**CHANGE ORDER NO.: 3**

Owner:	Town of Bristol	Owner's Project No.:	WW22532001
Engineer:	Commonwealth Engineers, Inc.	Engineer's Project No.:	S22145
		Contractor's Project	
Contractor:	Crosby Construction	No.:	24105-01
Project:	WWTP Improvement Project		
Contract Name:	WWTP Improvement Project		
	Effective Date of Change		
Date Issued:	Order:

Description: Eliminate Decorative Masonry and Veneers/paint exteriors of SBR and headworks, add fence along SBR property line, upsize bulk chemical tank, and procure/install new influent autosampler and procure new portable autosampler

Town of Bristol  
WWTP Improvements Project  
Change Order #3

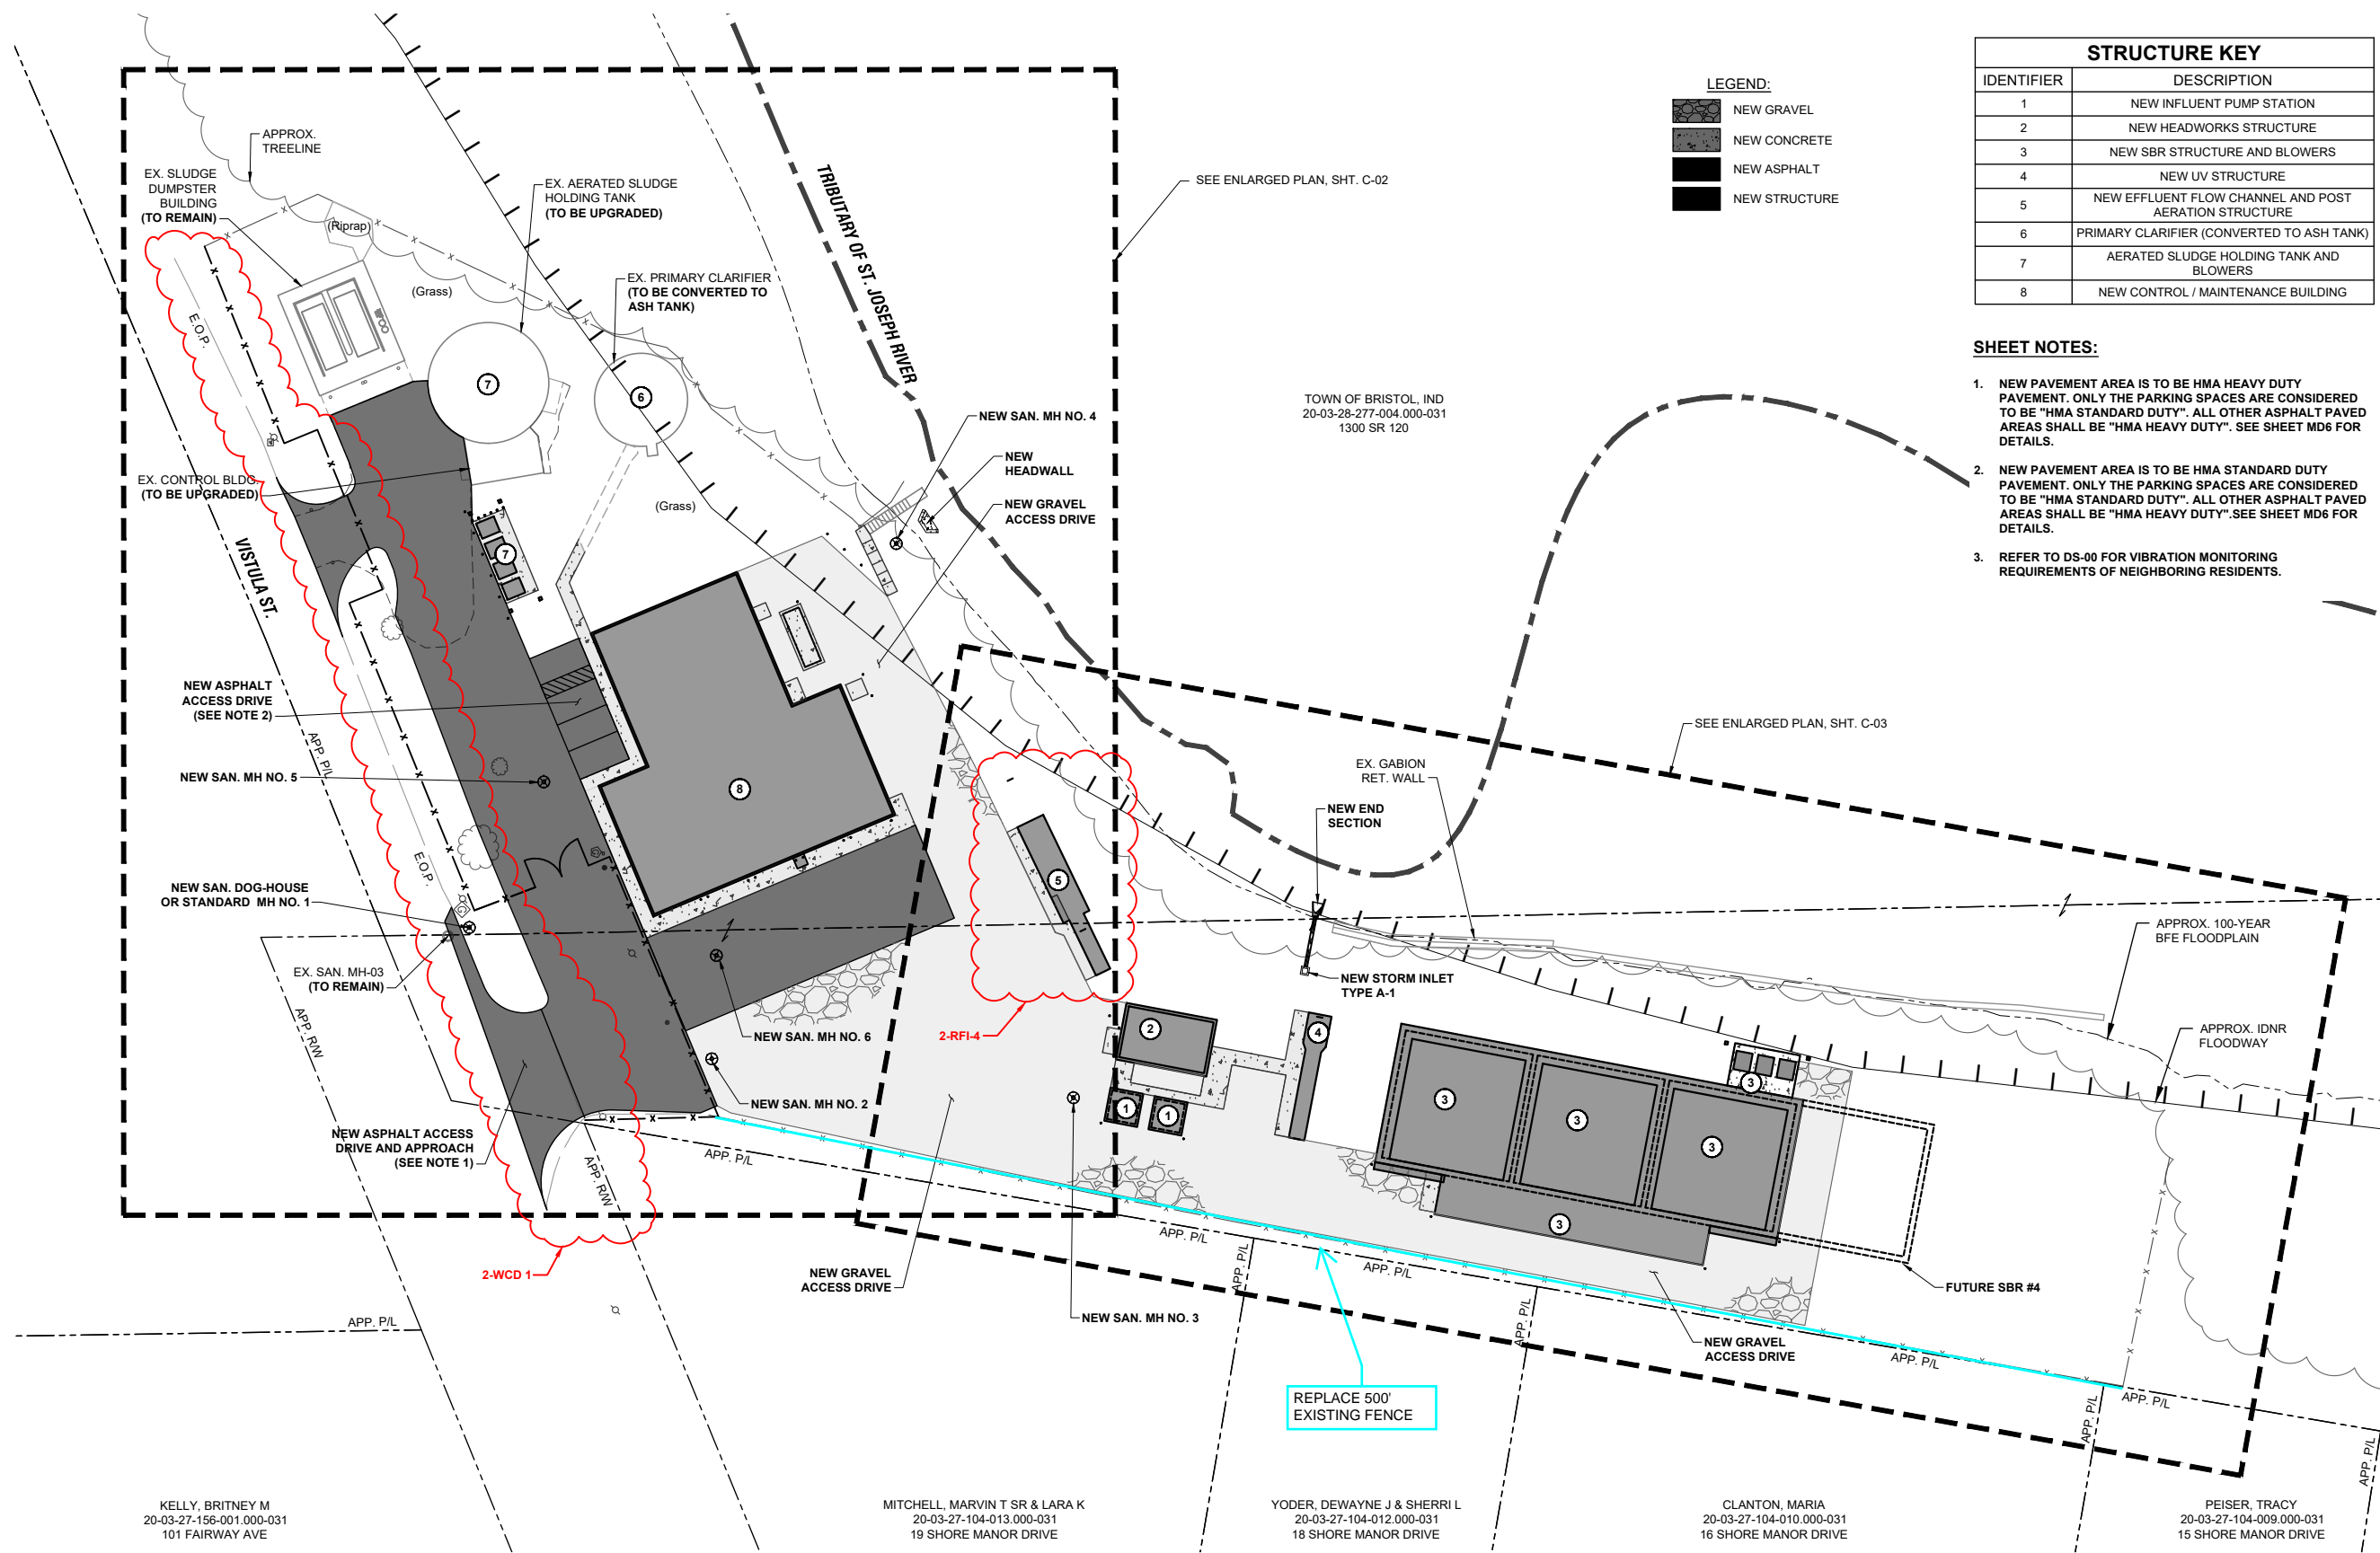
Submit fence design for approval of appearance. The Town likes the appearance of the fence below:
